# UNITED STATES PATENT AND TRADEMARK OFFICE

APPLICATION NO.	FILING DATE	FIRST NAMED INVENTOR	ATTORNEY DOCKET NO.	CONFIRMATION NO.
10/811,102	03/26/2004	Martin Weigert	16274.159a	9738

# Office Action Summary

## DETAILED ACTION

FIG. 1

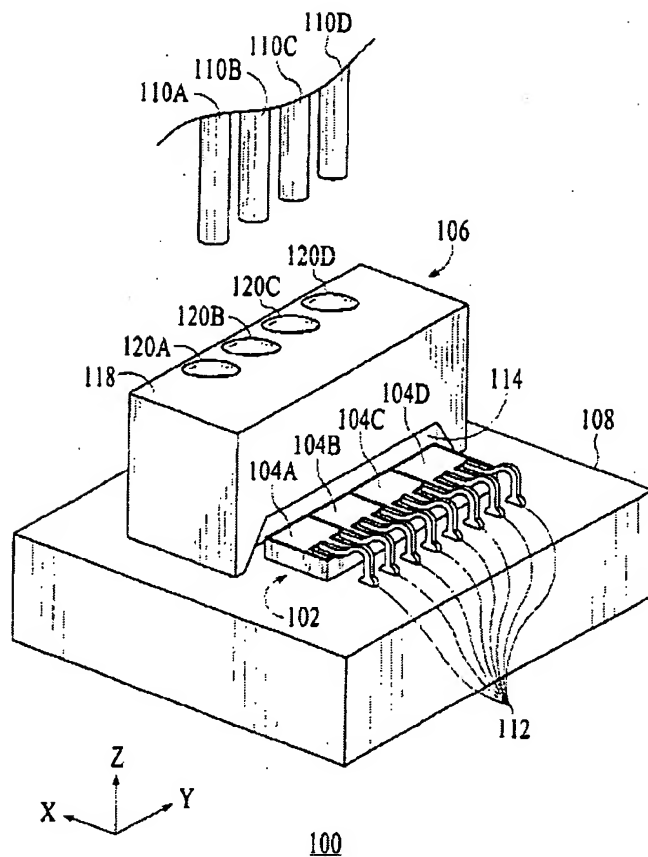
*In re* claims 1, 4, 8, 13, 14, 27, and 29, Wilson discloses an electrooptical module (100), comprising:

at least two electrooptical components (104A-104D) supported by a top surface of a common carrier (108) and operably coupled to an one optical waveguide (110A-110D), wherein:

the optical waveguide (110A-110D) is disposed above the top surface of the carrier (108);

the at least two electrooptical components (104A-104D) each are in an optical free-beam connection with the optical waveguide (110A-110D) by means of at least one lens (120A-120D);

as disclosed by Wilson at column 4, lines 17-19, the output lights from each of the lenses (120A-120D) may propagate "off-axis" and, therefore, Wilson clearly suggests the optical axis of each of the light beams could converge into the same waveguide;

wherein the at least two electrooptical components (104A-104D) comprises edge-emitting lasers arranged in a row (column 2, lines 60-62),

the electro optical module (100) further comprising a supporting element (106) that has reflective coating (116, shown in Fig. 2) assigned to the laser or the lasers, the supporting element (106) and the reflectively coating (116) being arranged in such a way that they reflect the light emitted by the laser or by the lasers (104A-104D) about 90 degrees onto the respectively assigned lens (column 3, lines 29-36). Figure 1 of Wilson is reproduced below.

*In re* claim 2, the use of an "optical squint angle" for the lenses (120A-120D) is clearly suggested in Wilson's disclosure at column 4, lines 15-20 in view of Fig. 3. Furthermore, the waveguides (110A-110D) are arranged perpendicular to the top surface of carrier (108) as seen in Fig. 1.

*In re* claim 5, the lenses (120A-120D) are arranged on the supporting element (106) and located spatially above the electrooptical components (104A-104D) as seen in Fig. 1.

A modified Figure 1 of Trezza is reproduced below. Additional labeling has been provided to Figure 1 of Trezza to more clearly show the claimed features.

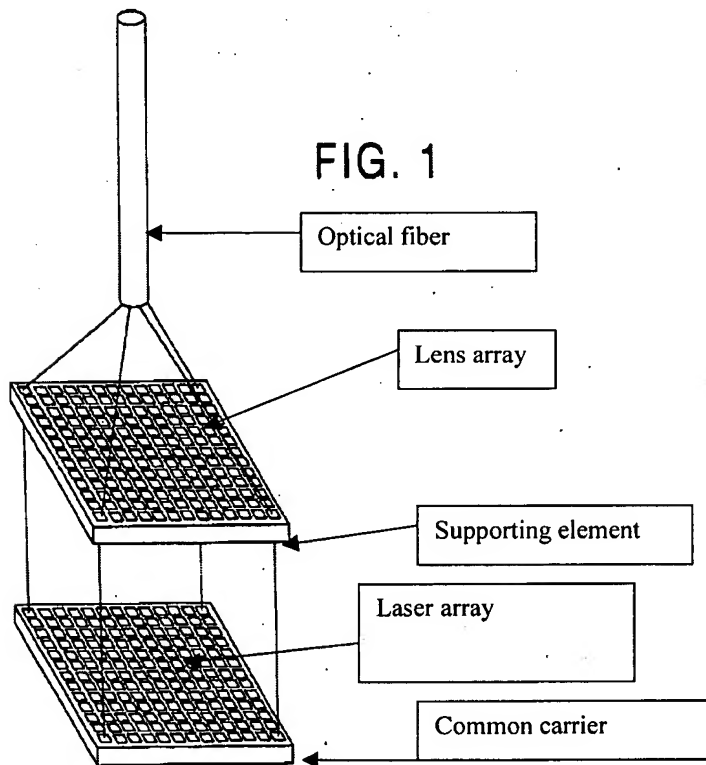
*In re* claims 1 and 8, Trezza discloses an electrooptical module (e.g., Figures 1-3), comprising:  
at least two lasers supported by a common carrier and operably coupled to at least one optical fiber, wherein the optical fiber is disposed above the carrier;

the at least two lasers are in an optical free-beam connection with the optical fiber by means of at least one lens;

all the light from each of the lenses intersects the optical fiber at about the same point;  
and

*In re* claims 2-5, 11-13, and 25, the specific limitations are clearly apparent from Trezza's disclosure at column 1, line 42 to column 2, line 21 in view of the modified Fig. 1 shown above.
